Mid-Inspection Questions with the NRC for
Waterford 3 Steam Generators during RF13

May 1 WF3 Steam Generator Inspection Report (Not Final)

Questions for NRC on SG Inspection at Waterford 3

FIGURE 2.4.5
SCNGS-2 STEAM GENERATOR LOWER "BATWING" ASSEMBLY

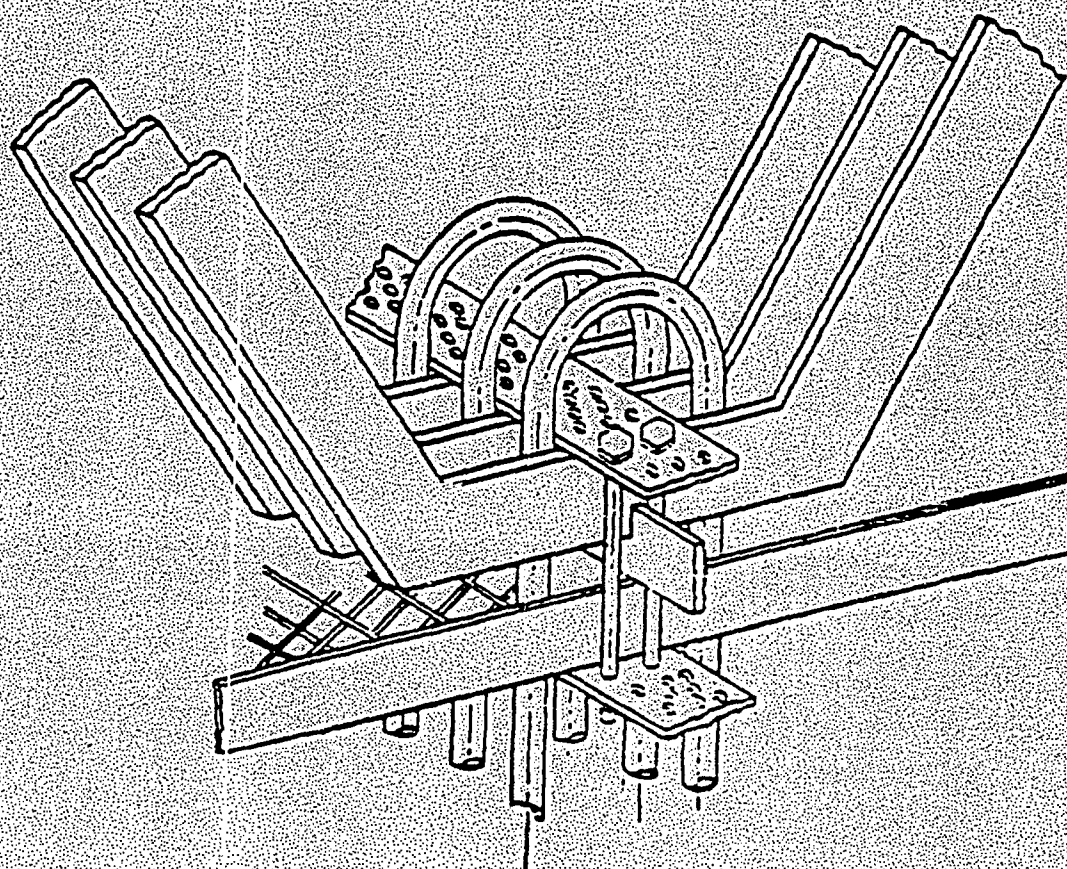
The new area that cracking was identified is as follows:

- Cracking in the vertical straps (axial)

There were 3 axial cracks identified in the vertical straps in the batwings.

FIGURE 2.4.4
SONGS-2 STEAM GENERATOR UPPER "BATWING" ASSEMBLY

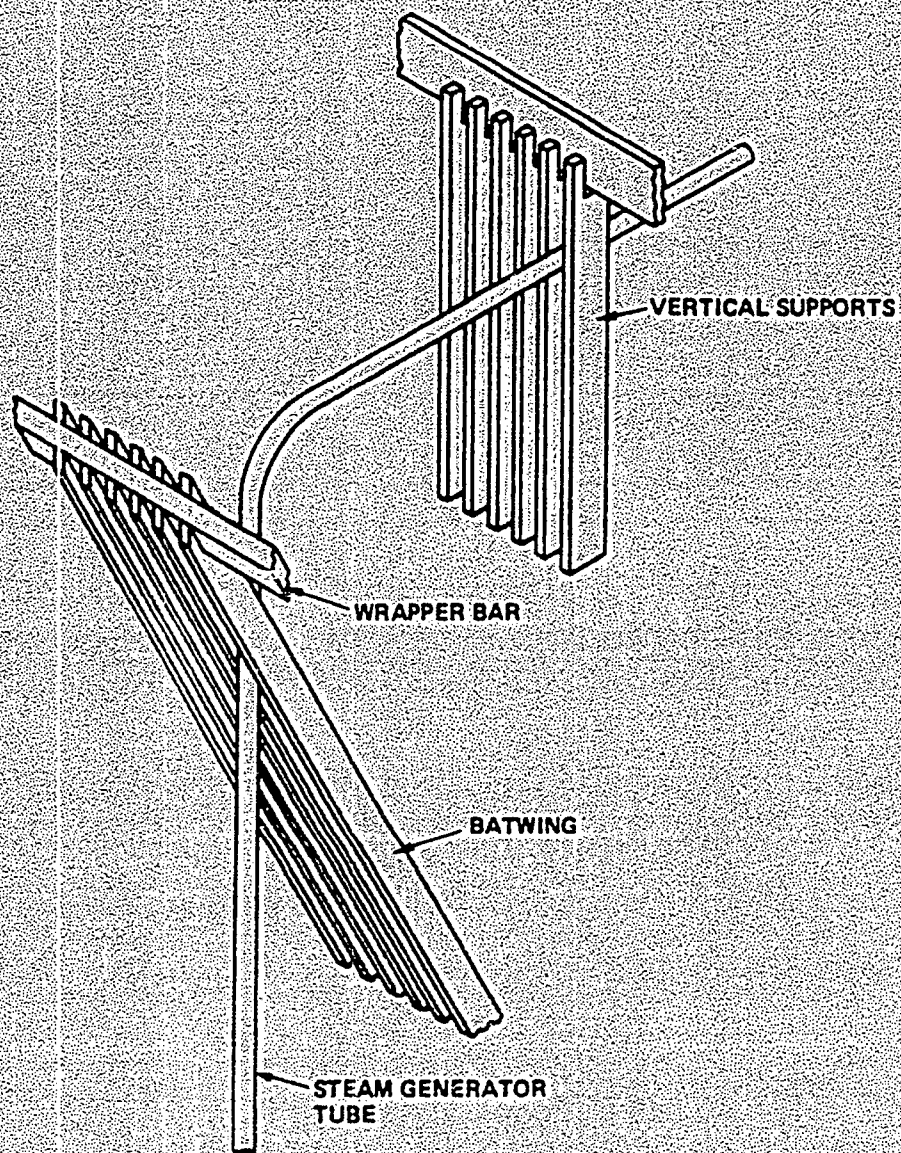
Diagonal Bar
BW1 and BW9

Vertical Straps BW2 - BW8

Partial Encasement Supports
03, 05 and 10 Hot Leg and Cold Leg

Full Encasement Supports
07 Hot Leg and Cold Leg
